State Water Resources Control Board

November 19, 2021

KINGS GROUNDWATER SUSTAINABILITY PLANS, GROUNDWATER SUBBASIN NO. 5-022.08

Appendix – Select constituents in Kings Subbasin wells

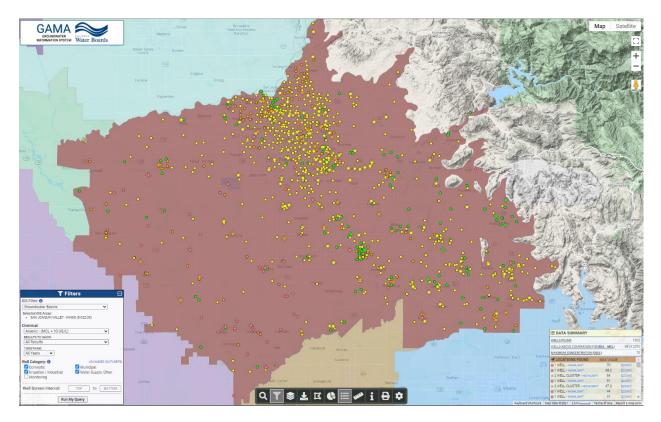
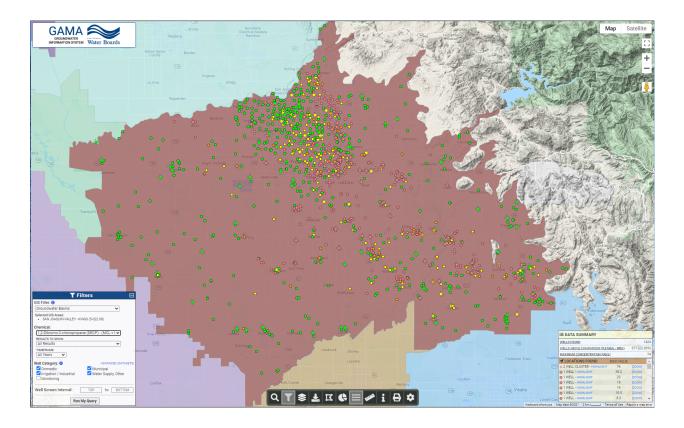
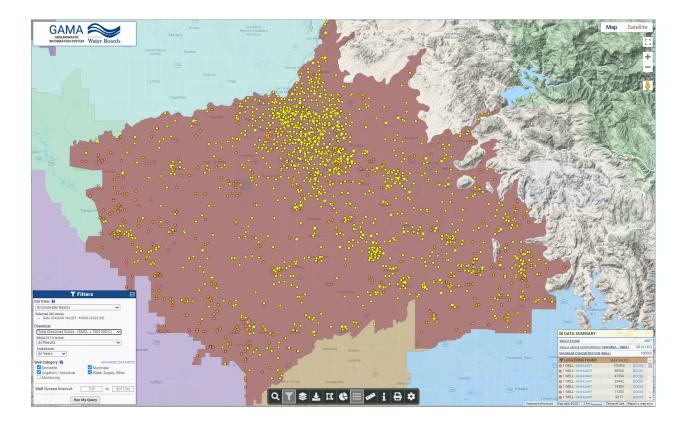
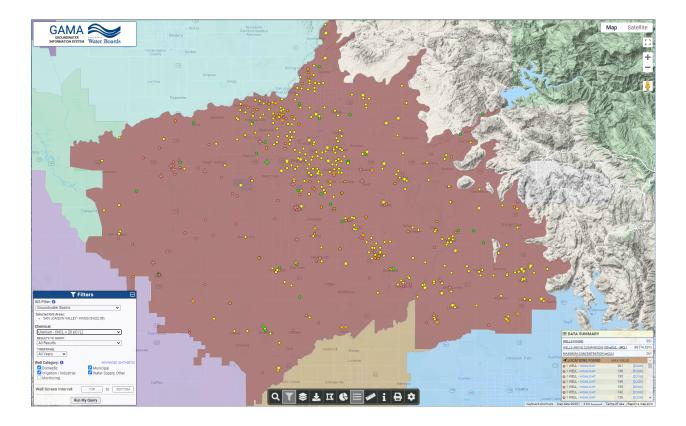
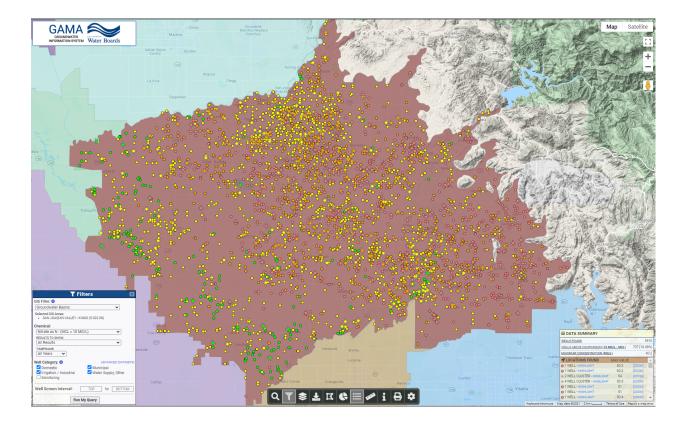
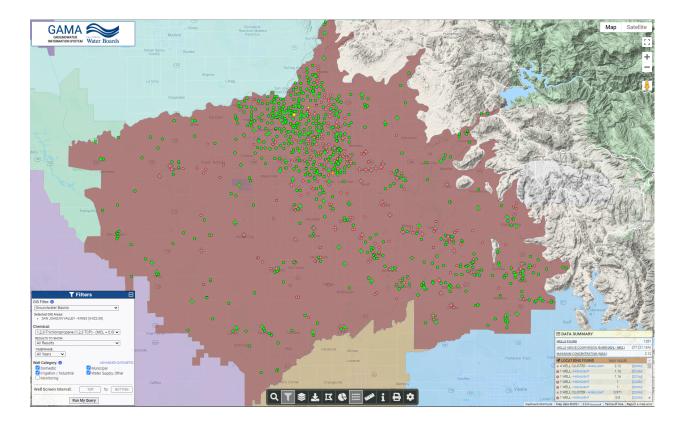
Staff recommends the GSPs incorporate other sources of available data (e.g., the Fresno County Rural Domestic Well Program, ILRP and CV-SALTS) and historic GAMA data over a longer time span. The <u>State Water Board Groundwater Ambient</u> <u>Monitoring and Assessment (GAMA) Program's database is available online</u> (<u>https://gamagroundwater.waterboards.ca.gov/</u>). The GSPs should also fill in depth-related data gaps to improve its understanding of water quality conditions. Appendix A shows mapping of GAMA results (all years) for nitrate, arsenic, 1,2,3-TCP, DBCP, and uranium, and hexavalent chromium in domestic and public supply, and

irrigation wells. These figures show impacts from these constituents are more widespread than otherwise discussed in the GSPs.

Staff has attached maps from the <u>State Water Board Groundwater Ambient</u> <u>Monitoring and Assessment (GAMA) Program's database</u> (<u>https://gamagroundwater.waterboards.ca.gov/</u>) showing TDS, arsenic, nitrate, uranium, DBCP, and 1,2,3-TCP impacts in subbasin groundwater (Figures 1 through 6 in Appendix).

Staff recommends the GSAs coordinate to define undesirable results consistently for the subbasin, manage for the same set of constituents in SMC, and have coordinated monitoring well locations and sampling frequencies. Based on their prevalence within the subbasin, all of the GSAs should include, at minimum, SMC for TDS, arsenic, nitrate, uranium, DBCP, and 1,2,3-TCP.
